# Access Compliance Report

## Public Rights-of-Way

Intersection ID: 32314	Main Street: CAMDEN_TRAIL_CT	Cross Street: NEW_PROVIDENCE_LN	Location: NE
ADA ID: 7DA91FC7D9CE	Ramp Type: PerpDiag	Initial Pass/Fail: Pass	Overall Compliance: No
Codes/Mitigation Info/Possible Solution			Severity Score: 10
			Field Measurements/Component Compliance

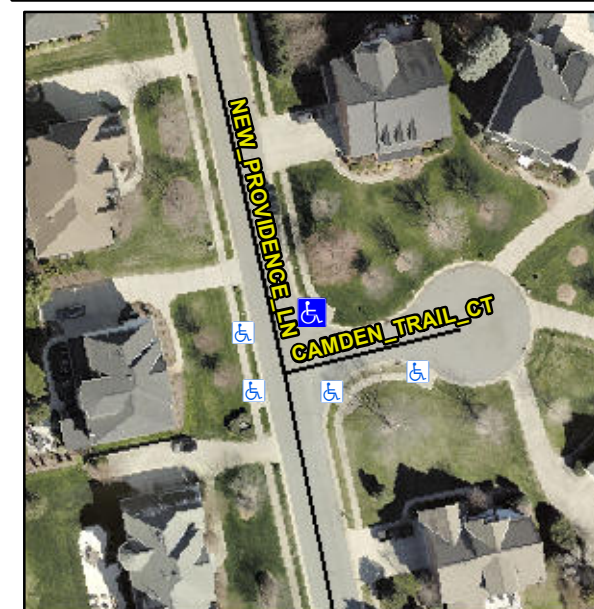
**Remove & Replace Curb Ramp With Two New Directional Ramps or Equivalent. Remove & Replace Gutter.**

**Not Found, R304.2.1, R305, R304.5.3**
